From: Troy [REDACTED]
Sent: 17 February 2021 9:06 AM
To: Matthew [REDACTED] Chloe Morris
Cc: Kon [REDACTED]
Subject: RE: [REDACTED] - RFI 002 (Setout - Dimensions for Basement)

Subject: [REDACTED] - RFI 002 (Setout - Dimensions for Basement)

Please find RFI concerning urgent query into the basement set out.

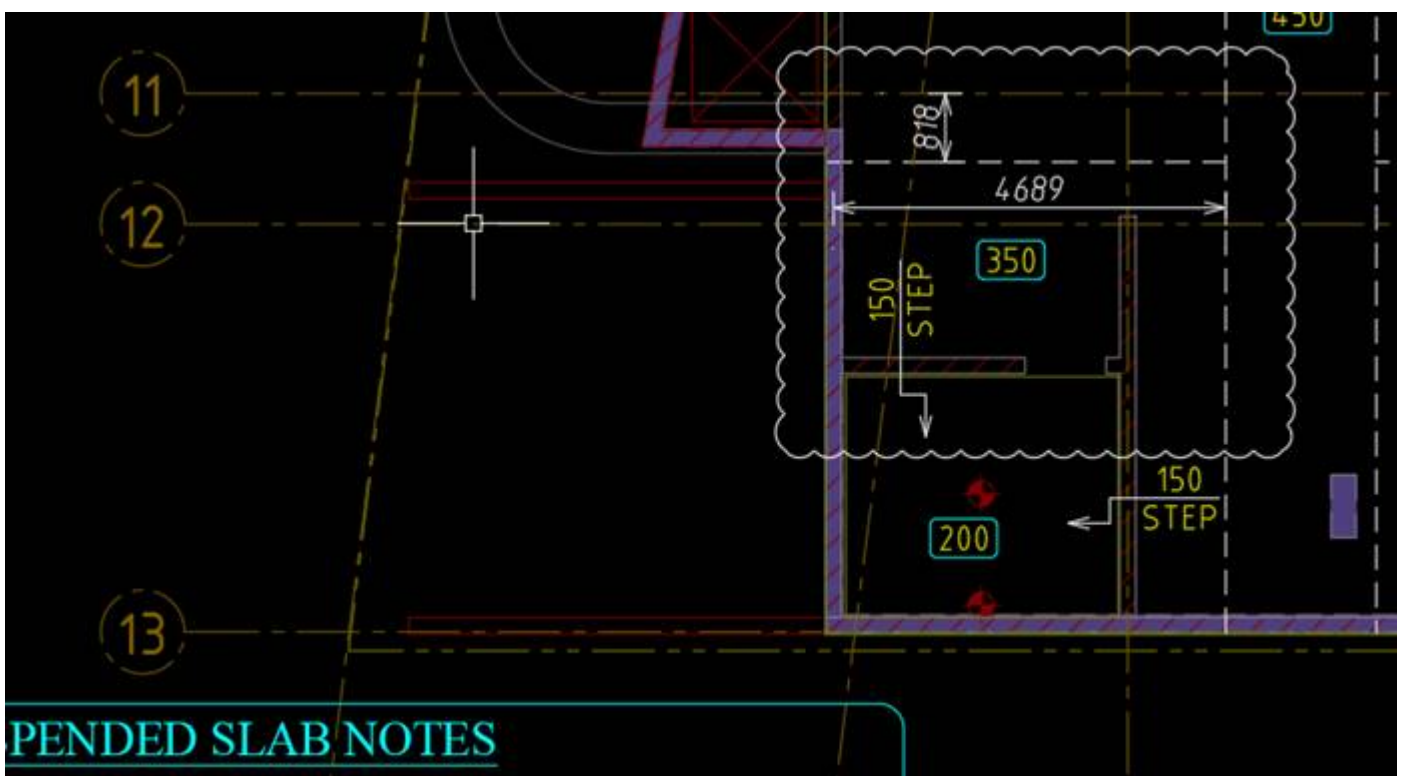
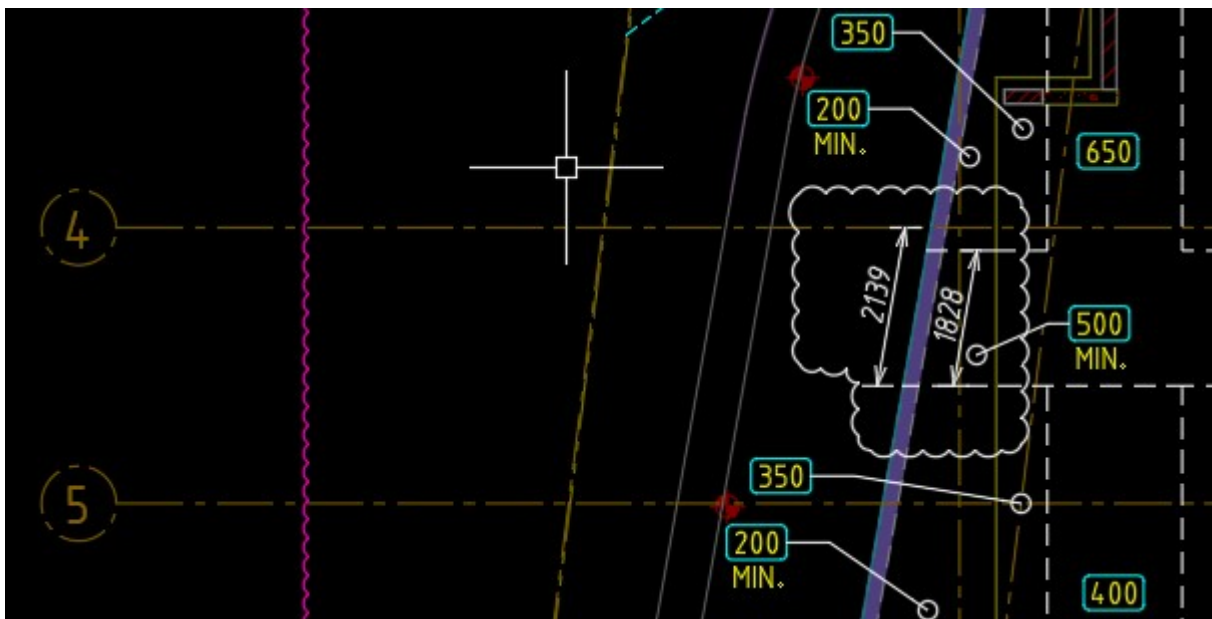
Can you please review the highlighted area below. Is the soffit of the slab stepping in this location? Does the slab thickness change?

No there is no soffit step at that location. See below screen shots from my drafty also to assist with the set out
